Re: BC Utilities Commission  
Pacific Northern Gas Inc. Application for Acceptance of 2019 Consolidated Resource  
Plan and for Acceptance of Energy Conservation and Innovation Portfolio Funding for  
2020 and 2022  
B.C. Sustainable Energy Association Information Request No. 1

REQUESTOR NAME: **BC Sustainable Energy Association**

TO: **Pacific Northern Gas Ltd. and Pacific Northern Gas (N.E.) Ltd.**

APPLICATION NAME: **Application for Acceptance of 2019 Consolidated Resource Plan and for Acceptance of Energy Conservation and Innovation (ECI) Portfolio Funding for 2020 and 2022**

Figure 4: Interest in Programs and Services – Residential Survey  
Percent of Survey Respondents – Very or Extremely Interested

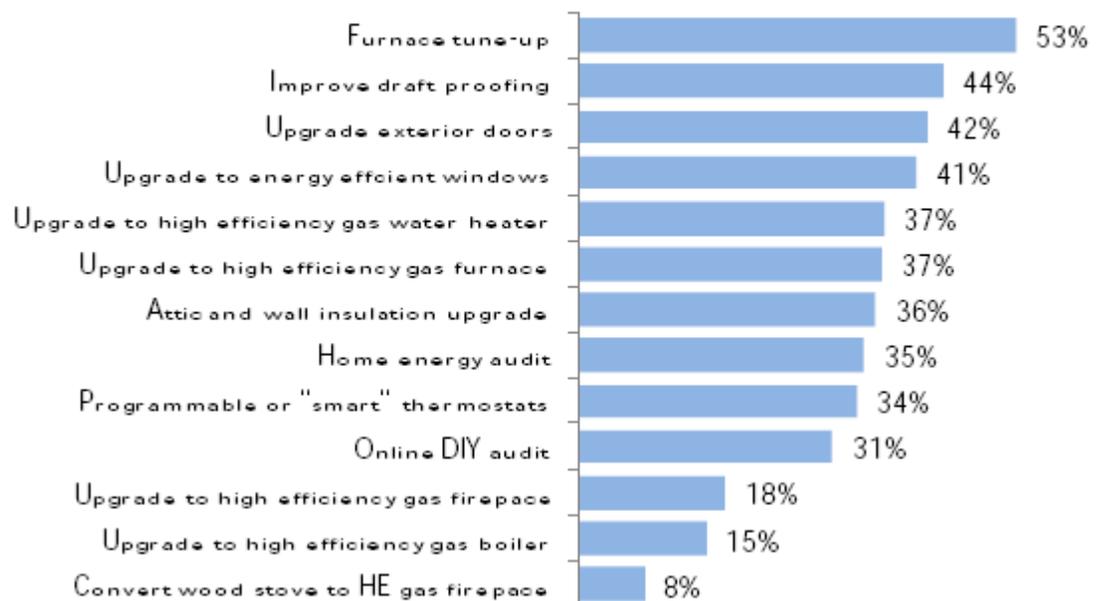
10.4 Does PNG intend to include customer education in its roll-out of biomethane?

Figure 15: Interest in Programs and Services – Commercial Customers  
Percent of Respondents – Very or Extremely Interested

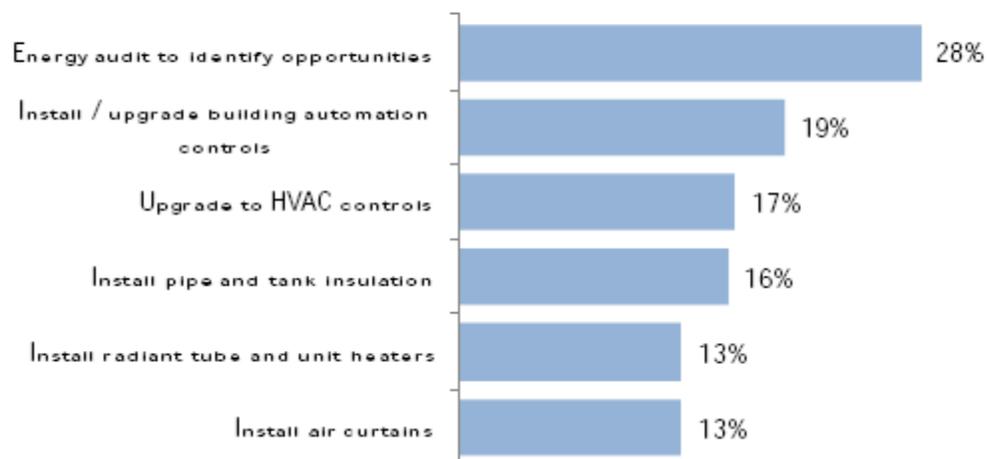
10.5 Please explain how the proposed four Commercial programs in the 2019 DSM Plan relate to the measures in which Commercial Customer respondents expressed the most interest in the 2019 Customer Survey. Which of the measures addressed in the Survey are included in the proposed DSM portfolio?

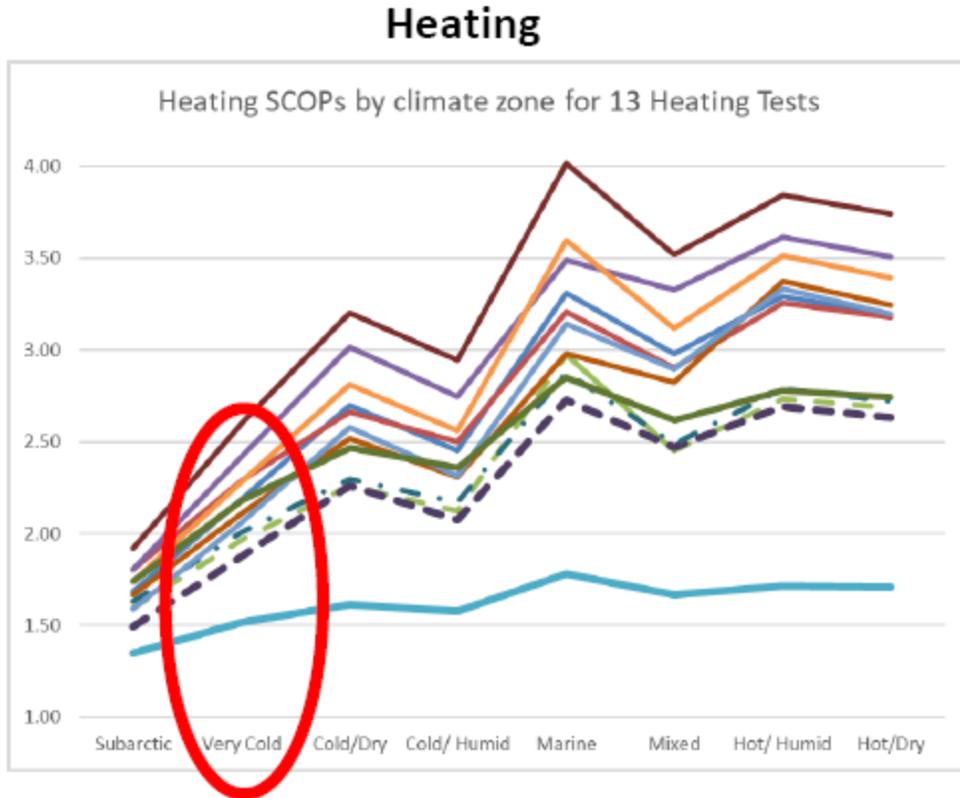
oval shape added by BCSEA highlights SCOPs ranging from 1.5 to 2.5 for the Very-Cold climate zone.

- 25.1 Is PNG's service territory in the Very Cold climate zone in the classification used in the NEEA presentation?
- 25.2 Is PNG familiar with the work of the Canadian Standards Association (CSA), the Northwest Energy Efficiency Alliance (NEEA) and other organizations to implement testing procedures to assess the heating Seasonal Coefficient of Performance of air source heat pumps for climate zones across North America?
- 25.3 Would PNG agree that air source heat pumps can achieve seasonal coefficients of performance substantially greater than unity even in the Very Cold climate zone?

Figure 5-17. Top 40 Measures for Gas Energy Market Savings Potential in 2025 (TJ/year)

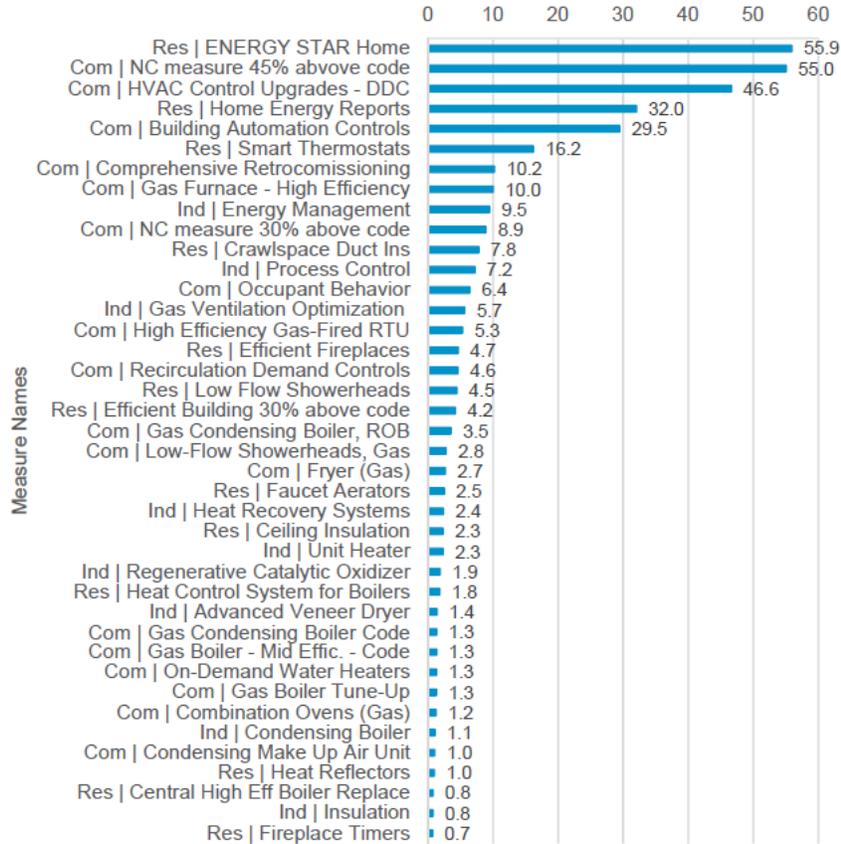
- 43.1 Please reproduce Figure 5-17 showing the top 40 measures for the economic potential.
- 43.2 Please provide a full listing of the measures that were included in the technical potential, economic potential, and market potential, along with the estimated costs and savings for each at the measure and aggregated measure level, and the benefit-cost test ratios (TRC, UC, PCT and RIM).
